**CONTINUING ELIGIBILITY INSPECTION (CEI) REPORT FOR
FLOOD CONTROL WORKS (FEDERAL)**
Honolulu Engineer District
CEPOH-EC-T

1. Project Name: Asan River Flood Control Project
2. Date of Inspection: February 9, 2006
3. Inspection Personnel:

Project Rating: “S, **Satisfactory**”
Project Condition Code: “A, **Acceptable**”
Project Status: “**Active**”

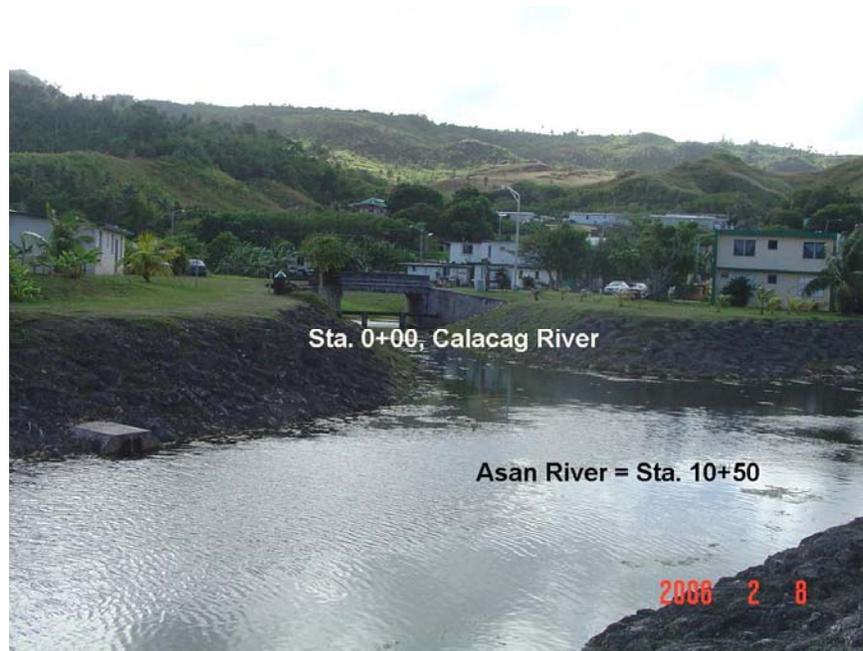
- d. Sta. 8+60, RB, 18" outlet clean, good maintenance, new river gauges installed this FY.

Sta. 11+50, RB, Remove Trees and Encroachments

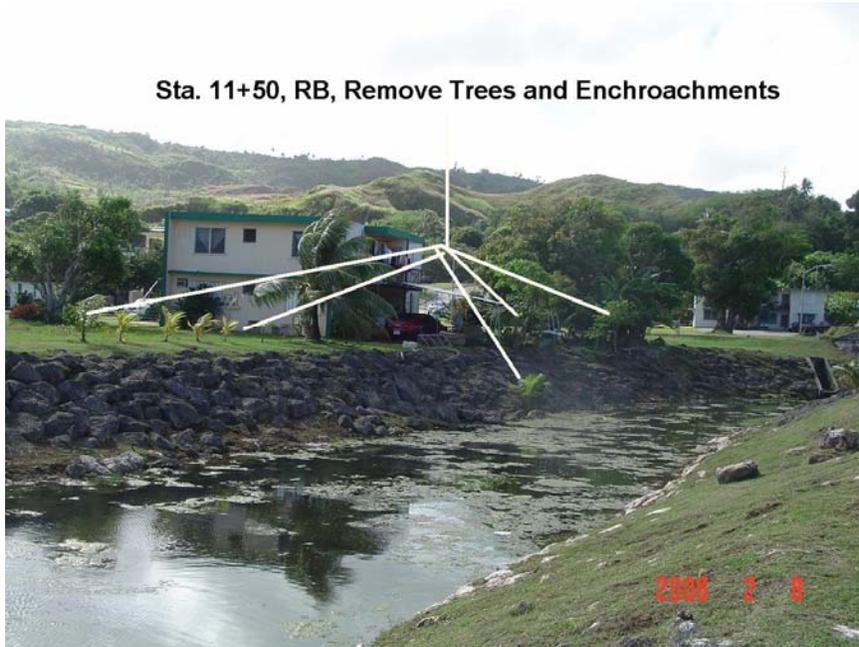
- h. Sta. 11+50, RB, remove juvenile trees within 5 ft. from top of sideslope and remove vegetation from riprap sideslope.

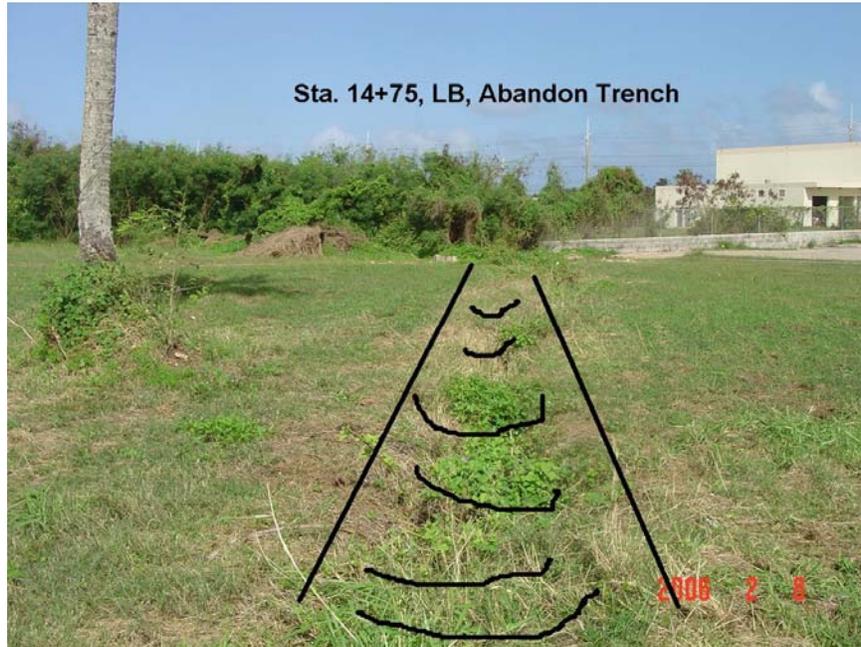
j. Sta. 14+00, LB & RB, monitor erosion at toe of CRM.

**Sta. 4+00, RB, Remove Coconut Tree from Maintenance
Access Rd.**

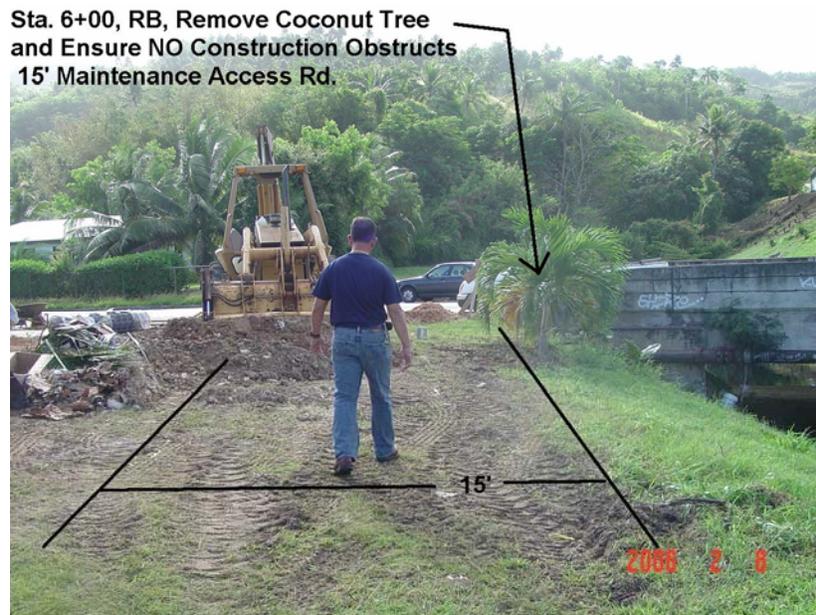
- f. Sta. 4+00, RB, remove coconut tree and restore 15 ft. maintenance access road for the entire RB side of the project.
